Deerfoot Trail Study

Deerfoot Trail Phase 3: What we Heard

February 12, 2020

Beddington Trail N.E.

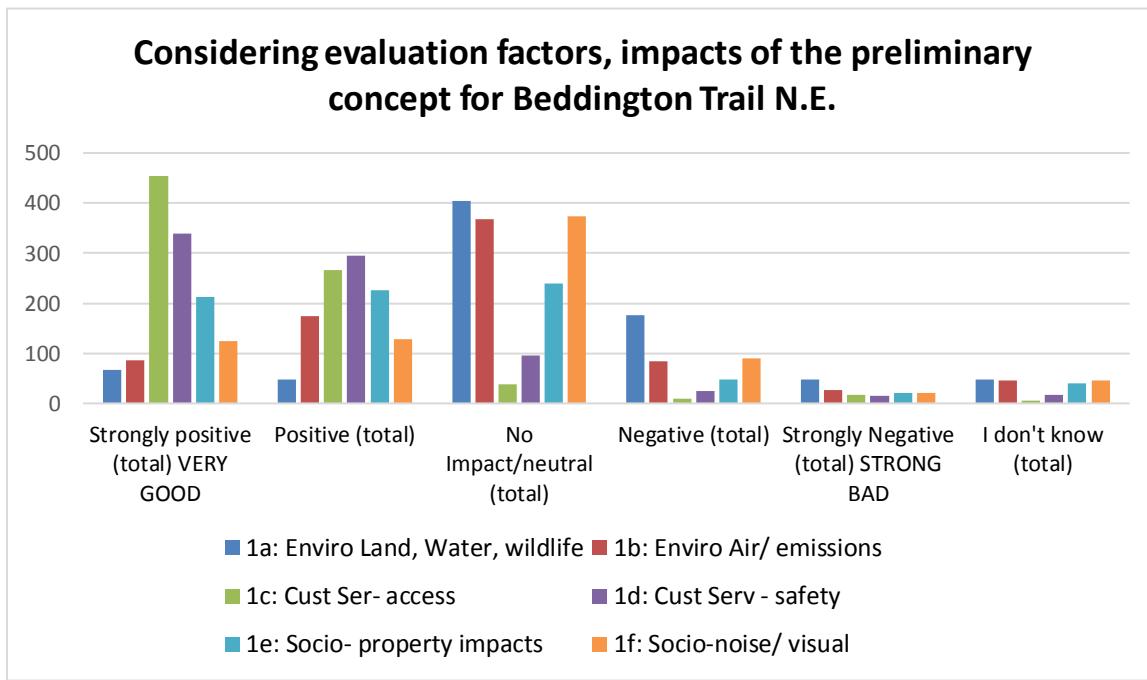
When asked about the proposed concept to Beddington Trail N.E., many participants indicated general agreement for the long-term concept presented while only some indicated disagreement, and others who made some targeted suggestions to the concept presented and additional problem identification about the interchange area. These top themes have been captured below and are supported by participant (unedited) verbatim comments.

- solution provides more access, but does not resolve congestion, which is the main issue.
- I think there are other easy alternatives for people to access deerfoot from the Beddington area
- Stop wasting money on building for more traffic
- This concept doesn't make sense. There schematic implies that SB and NB Deerfoot traffic will come together at the same time as NB 11 Street traffic to go WB on Beddington Trail.
- Shouldn't you be looking at the weaving that happens when traffic coming from McKnight as well as 64th Ave enters into Deerfoot Tr N and traffic exiting at Beddington? how about a "collector" lane?
- Expanding highway infrastructure induces demand and does not result in meaningful improvements.
- Seems like overkill to provide all-access interchange from/to 11St NE - seems like a limited area that will benefit from these improvements. \$ better spent elsewhere.

- We like the proposed design, but would like you to consider taking southbound traffic on Deerfoot that needs to exit to 64th Ave, please provide an exit lane before Beddington Trail. This would greatly eliminate weaving of traffic and conflict between traffic merging onto Deerfoot from Beddington and Traffic exiting for 64th Ave.

- I live in Beddington. I would use a connection from EB Beddington to NB Deerfoot very infrequently and probably on weekends only. Going south to 64 Ave and then turning north is fine.

- As for Deerfoot Tr. Improvements at Beddington Tr. you should consider making an exit from Hwy 2 South to 64 Ave. just after Airport Trail North of Beddington. Take the exit under Beddington and alongside of Deerfoot Tr. This area is a total mess because 2 lanes of traffic from Beddington is trying to get into Deerfoot while cars from Deerfoot South are trying exit to 64 Ave. lot of mix and mash as this point. If you make exit fro 64 Ave before Beddington entry to Deerfoot you will gain free flow from Beddington on to Deerfoot Tr. and no trouble for exiting cars to 64 Ave.

16th Ave. North

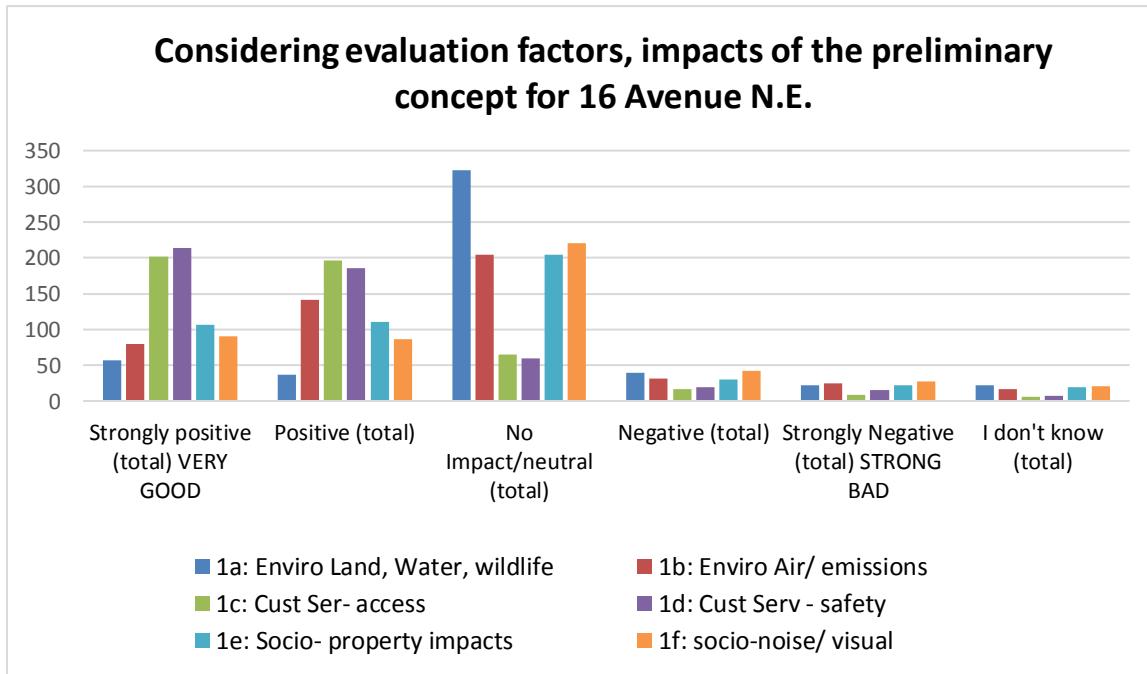
- Save the money. The road is fine. There isn't a lot of congestion here. People are just anxious and impatient. Interchange here would discourage people from going to Mayland Heights.

- Does not look like it solves anything, just causes more confusion.
- This appears to be a lot of money and work, along with a lot of short term traffic disruption, for extremely little long term impact. This would be huge waste of money.

- current plan is a stupid design, this interchange needs to be a cloverleaf, the current design is dangerous and ineffective

- The distance between merges and drivers on the ramps between the basket weavers and 19th st seems way too short
- this doesn't address the issue of slow downs that occur N bound b/w Memorial and 16th every single day after work hours

- love the concept and would definitely allow for more of a free flow but would like to see a better north bound off ramp
- The proposed interchange at 19 St NE & 16 Ave NE alone would accomplish 90% of the benefits of this concept. No need for weaving bridges or the bridge across Deerfoot (or that can be determined later)

- While this deals with east/west traffic, it does not address traffic going to/from Deerfoot. Fixing one problem while ignoring the other is wrong. Fix BOTH at the same time.

17th Ave / Memorial Dr. SE — Three Preliminary Concepts

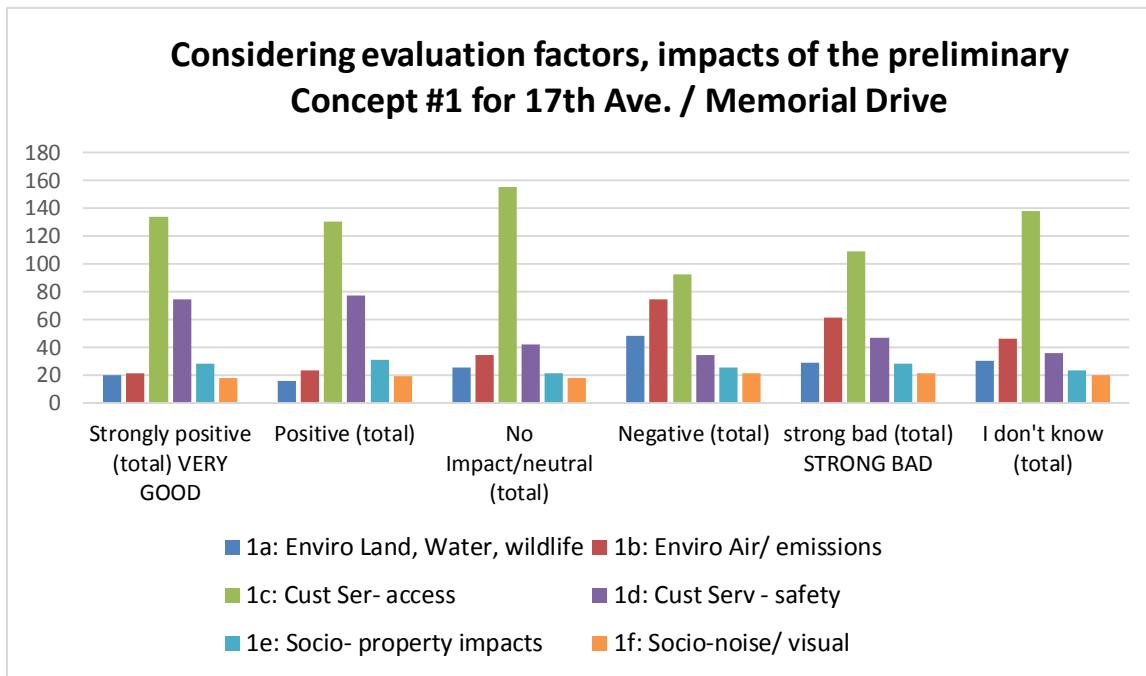
<p>changes in the future. Do it right the first time. Concept 1 best.</p> <ul style="list-style-type: none">• This is the most problematic intersection, trying to get onto northbound deerfoot can take up to an hour• during rush hour this is a total disaster accidents waiting to happen, especially people coming off deerfoot to memorial, it's so hard to move at rush hour and a lot of people won't let you in.• On the first 2 concepts, I like the idea of eliminating the Memorial Drive exit lanes and moving them effectively to Barlow Trail.
<p>Problem Identification <i>(About concepts for 17th Ave / Memorial Drive and areas of concern in the interchange area)</i></p>	<ul style="list-style-type: none">• These three concepts worry more about South of Memorial Drive. The main issues with the ENTIRE Deerfoot starts with the section North of Memorial Dr. The small off ramp from EB memorial to NB Deerfoot starts a chain reaction for congestion and accidents for the entire roadway. Vehicles cannot gain enough speed to properly merge with other vehicles doing 100km/h on the Deerfoot.• I actually feel preliminary concept #3 is the best one to address the weave in both directions of Deerfoot Trail, with the least impact on the west and east side of Deerfoot Trail. However, the intersection at Southbound Deerfoot and Memorial (specifically the configuration of the LRT tracks and where to stop safely for the lights) remains unchanged. This is a very dangerous design in its current state.• Scenario #1 - All this does is displace traffic onto Barlow. Additional light DD interchange will add confusion. Will not solve traffic off Deerfoot only creates backlog, people• You need that south ramp on to deerfoot, not create a mess inside the neighbourhood exiting to get to memorial. Interesting but waste of money, won't solve issues.• Scenario #2 - Like Blackfoot to Barlow. Being forced to exit @ 17th and Barlow to Memorial will not solve any issues. Double people exiting 1 exit instead of 1/2 @ exit and @ other will just make backlog between 17th and Peigan.• Option 1 and 2 would create too much traffic on Barlow trail. That area is prime for densification and should be focusing on improving access for transit/walking. I'd like to see the LRT crossing gone

<ul style="list-style-type: none">• Considering that Calgary Transit users pay a user fee to cover 50% of the operating cost, why not ensure there is a user fee to cover 50% of costs to anyone using Deerfoot?• Concept 2 appears to have bottlenecks going to/from southbound Deerfoot. Only a single lane in each direction. Due to that I support Concept 1 or 3. One benefit of 1 is Barlow will be easier to access• None of these plans address the congestion westbound 17th avenue over the river. Widen the bridge to 3 lanes westbound to accomodate all the westbound traffic or all this work won't solve anything.• Concept 1 would create the best situation however access to Max bell might be difficult from the north or south--maybe open an access off of memorial?
<p>Suggestion to the 17th Ave S.E / Memorial Drive Draft Concepts <i>(To specific concepts 1-3 or overall interchange area)</i></p>	<ul style="list-style-type: none">• Concept one would see the greatest increase in traffic flow and would manage it seamlessly. I would like ot see a lane added from north bound Barlow to south Barlow to keep traffic of deerfoot (N and S).• I believe #2 is the best choice for improving traffic flow and providing options for routing trating in incidents of traffic disruption. I would suggest 2 modifications for concept #2: have 2 lanes exit from NB Deerfoot to NB Barlow; explore if traffic circles instead of lighted intersections wouuble be better on either end of the Blackfoot Trail Bridge over Deerfoot.• Concept 3 is the most common sense and lowest overall impact. The route continuity broken by Concept 2 doesn't make as much sense and it is a nightmare to sign. It seems unlikely that a signalized intersection will handle all 17th ave traffic at the ramp traffic all turning. The diverging diamond is a good idea.• Build flyover from eastbound memorial to north bound deerfoot and make it 2 lanes. (concept 1 - prefer, concept 2 - neutral, concept 3 - NO)• On the first 2 concepts, I like the idea of eliminating the Memorial Drive exit lanes and moving them effectively to Barlow Trail.• What about getting rid of a canal of the side and that way they could be more lanes going through• The 17th/Memorial lanes create backup because of weaving and short ramp. Only concept 3 adequately deals with this. Concept 2 is OK, but

I hate the weave bridge--one over McLeod is confusing.

50 Ave. / Peigan Trail - One Preliminary Concept

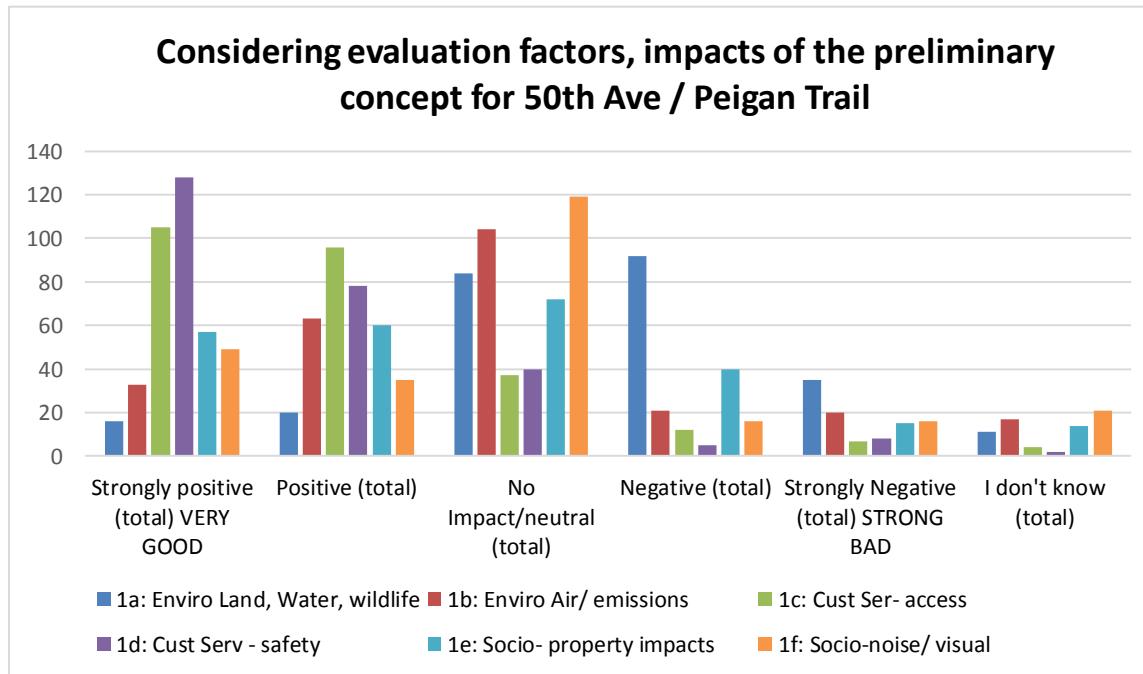
<p>Problem Identification <i>(To preliminary concept for 50 Ave / Peigan Trail and interchange area)</i></p>	<ul style="list-style-type: none">• Will the proposed new bridge take into consideration the angle of the sun during sunrise/sunset? I like that the calfrobe bridge will be used for another purpose.• If I'm understanding the map correctly, this gets rid of Peigan Trail/Deerfoot's access to each other. Would improve flow, could impact navigation for those leaving industrial area. Not sure I'm a fan• Access to parks is still required• The major cause of delays and accidents in this area are Pegian trail exit to Deerfoot N, deerfoot South exit to Pegian trail. This concept does not address these problems.

- This access would be great for cars & people & cyclists, but the river would suffer due to debris, eliminated animal habitat, etc. Can pre-fab construction methods be used to minimize time/impacts?
- Having a more connection to the industrial area west of Deerfoot, as well giving that side a more direct connection to east of Deerfoot is ideal
- Seems like a bad location to seek to make these changes. Icy conditions and high flood water area with a design that doesn't plan for this.

Glenmore Trail S.E. - One Preliminary Concept

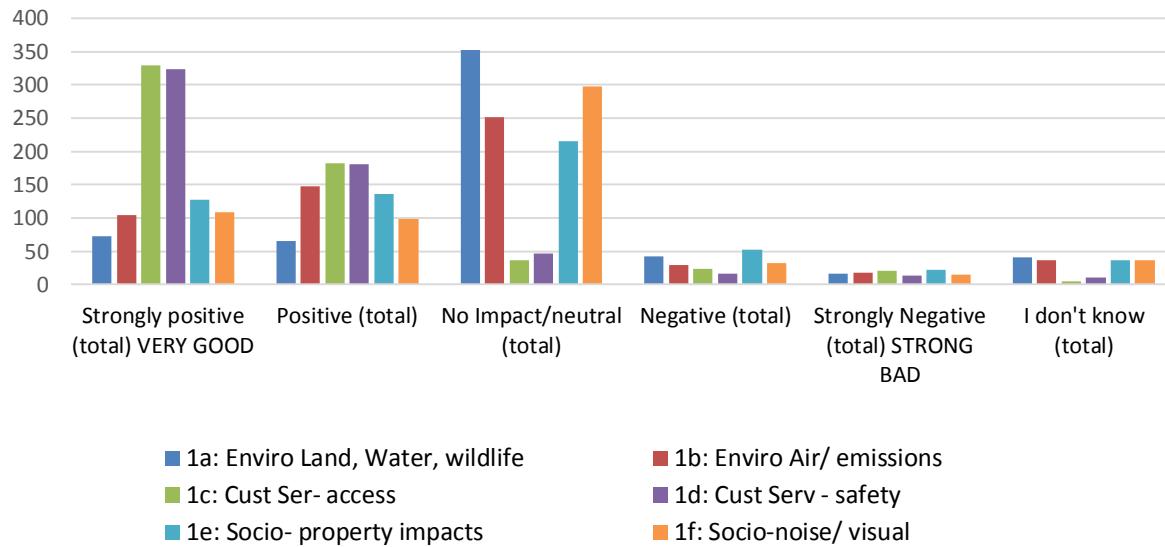
Top Themes That We Heard	Participant Verbatim Comments
	<ul style="list-style-type: none">• Looking forward to the elimination of the "Glenmore Squeeze". Northbound to Westbound movement very much improved. This is probably the highest priority, followed by Anderson/Bow Bottom.• This concept is so much better than the current design. It would greatly improve traffic flow.

<p>Overall General Agreement <i>(About preliminary concept for Glenmore Trail)</i></p>	<ul style="list-style-type: none">• This is one of the most critical interchanges in Calgary and desperately needs upgrading. The need far outweighs any potential negatives regarding property impacts or environmental considerations.• Current access sucks, needs improvement. This is a good proposed change.• Improving flow from NB Deerfoot to WB Glen more would be life altering. The time spent here is ridiculous. Bike pedestrian traffic could be diverted to Heritage as it is more likely to have traffic• Great to remove the detours through industrial/retail and condense all traffic to within the interchange• This should have been implemented back in ~2008. I support this to get rid of one two-lane pinch-point on Deerfoot.• Glenmore Trail...another historically normal road that we turned into a freeway, and somehow the traffic got worse. Build it, and they will come; alternatively, do not build it, and they won't..save \$

<p>Problem Identification <i>(Particular areas of concern in and around Glenmore Trail S.E. interchange and area)</i></p>	<ul style="list-style-type: none">• I think because the changes necessary to make this interchange more effective are so huge, it has been ignored or underserviced for a long time. Not much about the current interchange works well and as Quarry Park becomes busier and more traffic heads East of Deerfoot it seems that a crisis point is almost being reached here.• Avoid long back up of traffic - causes air pollution. More direct. Avoid a traffic light, in winter causes slippery road conditions, everybody stopping and starting in the same place.• I believe this intersection is one of many significant bottlenecks on Deerfoot and could use a major revamp• Like exiting Deerfoot N to Glenmore W (3 lanes each?) rather than Heritage Dr currently. Do not like Blackfoot N interchange turning left to get to Glenmore E, then Dft S (too much weaving)• The exit from Deerfoot south to Glenmore, going on Glenmore west is slow and high risk, especially coming off of the ramp to merge into Glenmore. The yield sign is almost a "stop" sign and a high risk "accident" area.• The interchange will change how to get to Glenmore. Going through Heritage now and snaking to Glenmore is a time waster. It isn't efficient at all.

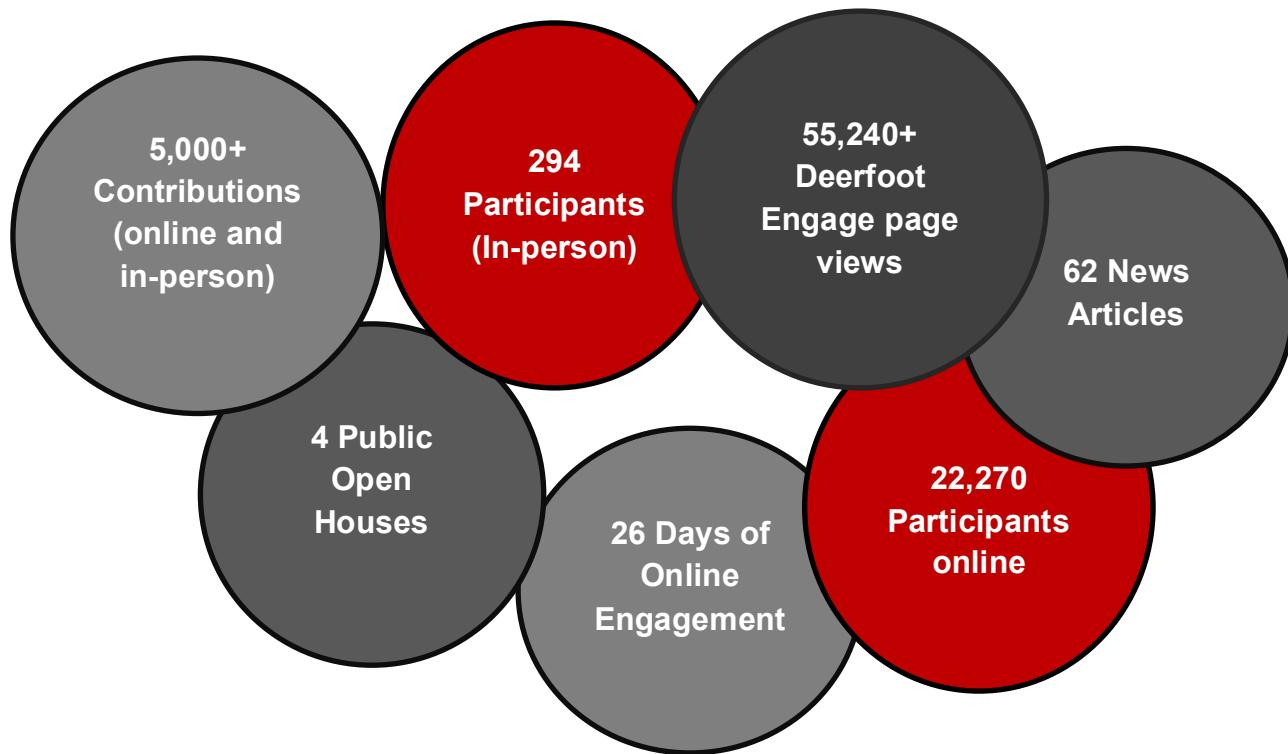
- Option 3 is the only option that fixes flow in both directions
- Prefer concept 3 because direct access to Southland/Blackfoot/shopping reduces much weaving. I hope signage is also improved on all concepts for all interchanges.

- 3 is best because it adds blackfoot access to deerfoot w/o Southland AND Ebound Southland to S Deerfoot access.
- If you're truly trying to fix the problems then go with the most robust plan (option 3 IMO). Add cycling options, continue to fund greenline & other transit to mitigate continued car commuter growth

- Option 3 is the only one that will truly positively impact this area.
- concept 1 & 2 look to provide little to no changes. Concept 3 looks to reduce lane switching and improve flow. The golf course probably should be considered to be closed anyways. No concern losing it.
